Approved for access by the Solid Waste Department.

Reviewer: Herman Gallegos

ECOS INFANTILES 319
SITE PLAN
319 7th STREET NW. 87102
ALBUQUERQUE, NM
PROJECT #2357

REVISION DATE	
DATE	2/26/2024
SHEET NUMBER	AS-1.0

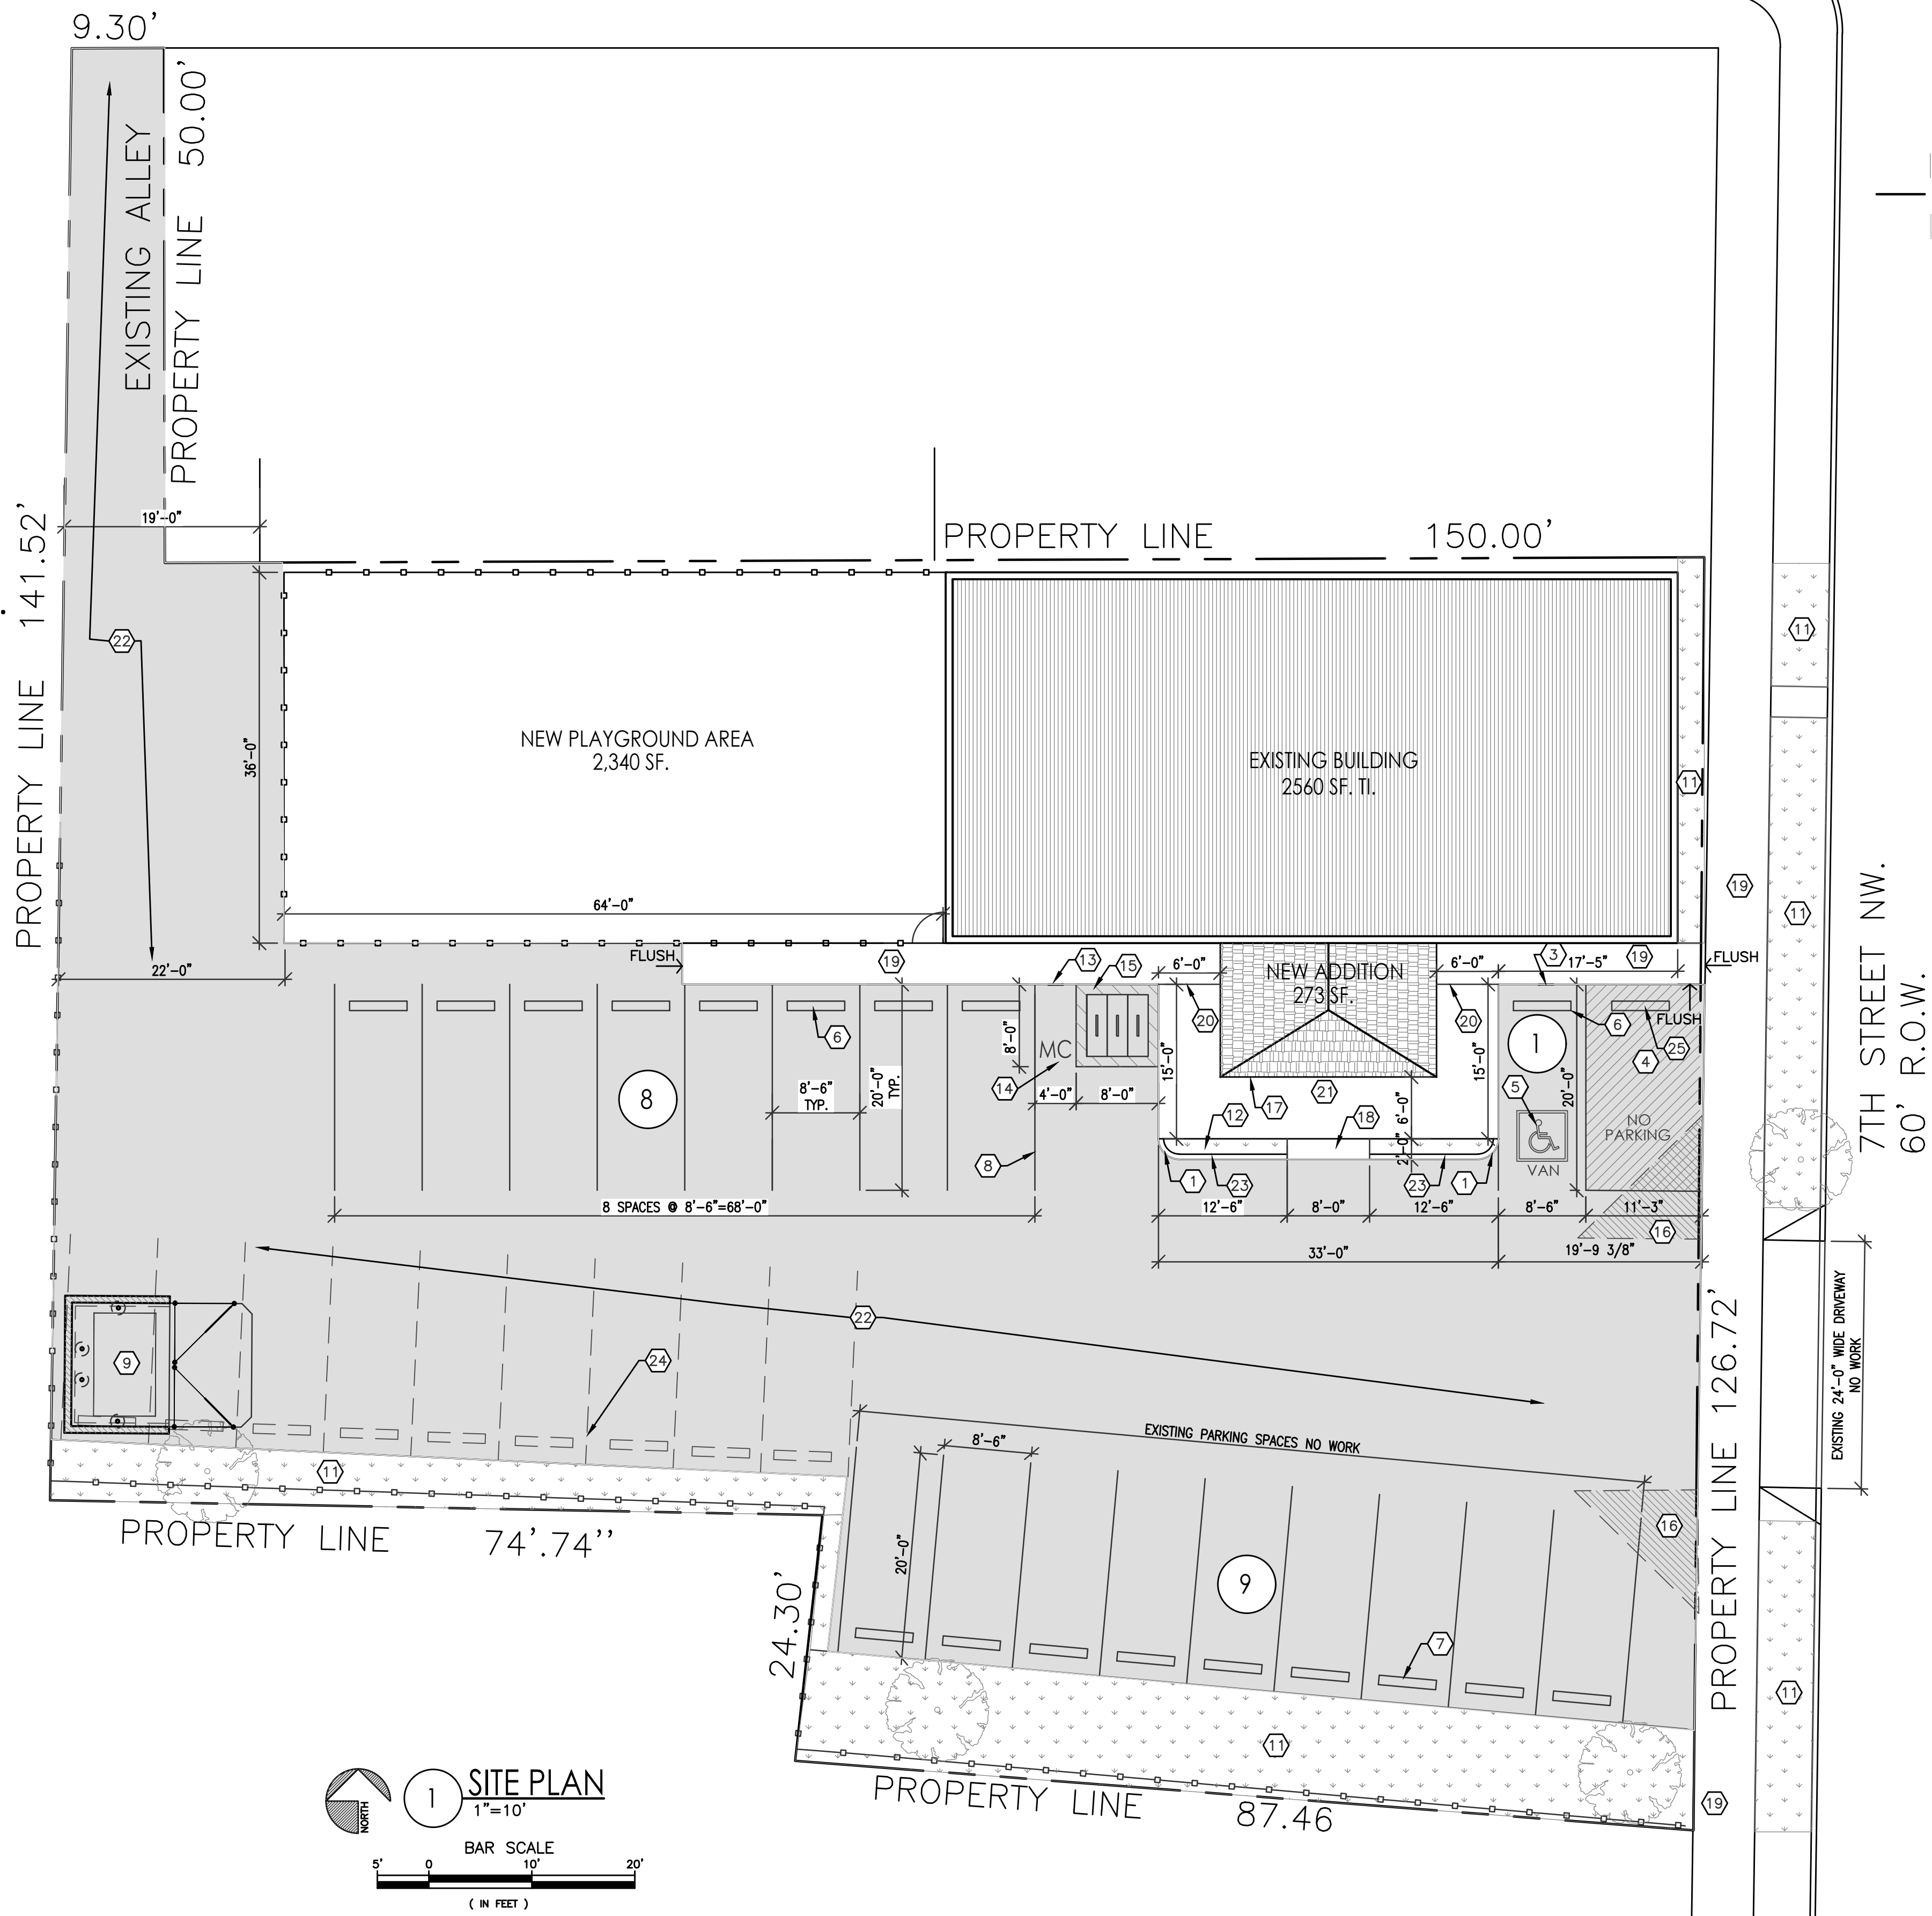
All containers must be made accessible for pick up

between the hours of 5AM and 8PM.

****Hazard Route Only there is no easement
agreement with the neighboring properties****

****Recycle Declined****
